UNITED STATES PATENT AND TRADEMARK OFFICE

APPLICATION NO.	FILING DATE	FIRST NAMED INVENTOR	ATTORNEY DOCKET NO.	CONFIRMATION NO.
10/643,267	08/19/2003	Takahiro Imamura	2500.68258	4628

Office Action Summary	Application No. 10/643,267	Applicant(s) IMAMURA ET AL.	
	Examiner Mark Blouin	Art Unit 2653

Detailed Action

EXAMINER'S DRAWING

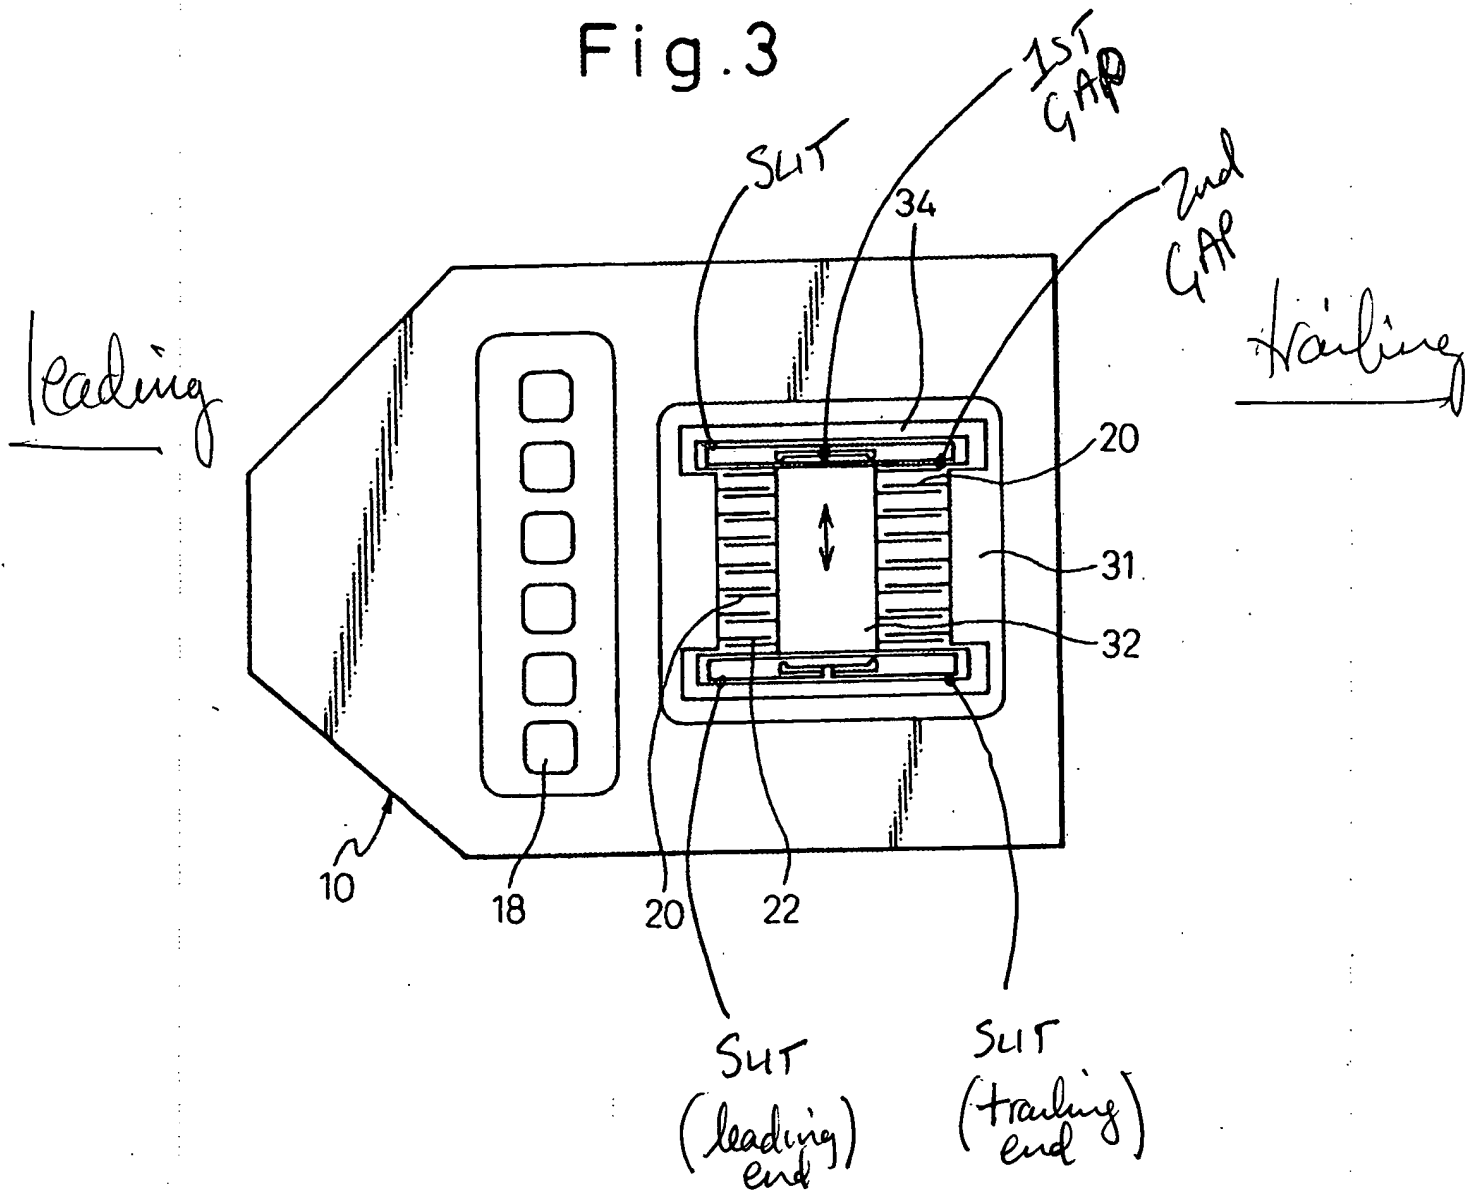
2. Claims 1-16 are rejected under 35 U.S.C. 102(b) as being anticipated by Imamura (USPN 6,359,752).
3. Regarding Claims 1 and 16, Imamura shows (Figs. 3-5), a head assembly comprising, a head suspension (30), a slider body (10) mounted on the head suspension, a slit (See Examiner's Drawing) defined in a trailing end surface of the slider body, the slit extending from a trailing end of the slider body toward a leading end of the slider body, a movable block (32) at least partly spaced from a stationary block (42) of the slider body by the slit, and a head element (43) mounted on a trailing end surface of the movable block.

13. Regarding Claim 11, Imamura shows (Figs. 3-5), the head slider, comprising another slit defined in the trailing end surface of the slider body, the other slit extending from the trailing end of the slider body toward the leading end of the slider body, wherein the movable block (32) is defined between the slits (see Examiner's Drawing).

16. Regarding Claim 14, Imamura shows (Figs. 3-5), the head slider, wherein the void includes a first gap extending between the slits so as to define a leading end of the movable block, and a pair of second gaps extending from opposite ends of the first gap toward the trailing end of the slider body, respectively, in parallel with the slits, the second gaps ending at positions spaced from the trailing end of the slider body (see Examiner's Drawing).

17. Regarding Claim 15, Imamura shows (Figs. 3-5), the head slider, wherein the second gaps extend from the opposite ends of the first gap toward the leading end of the slider body, respective, in parallel with the slits (see Examiner's Drawing).

The Examiner maintains that the slit shown in the Examiner's Drawing clearly extends from the leading end to the trailing end on the slider body, and that part of the slit is considered to be at a trailing end surface. Therefore, the rejection of Claims 1-16 are upheld.
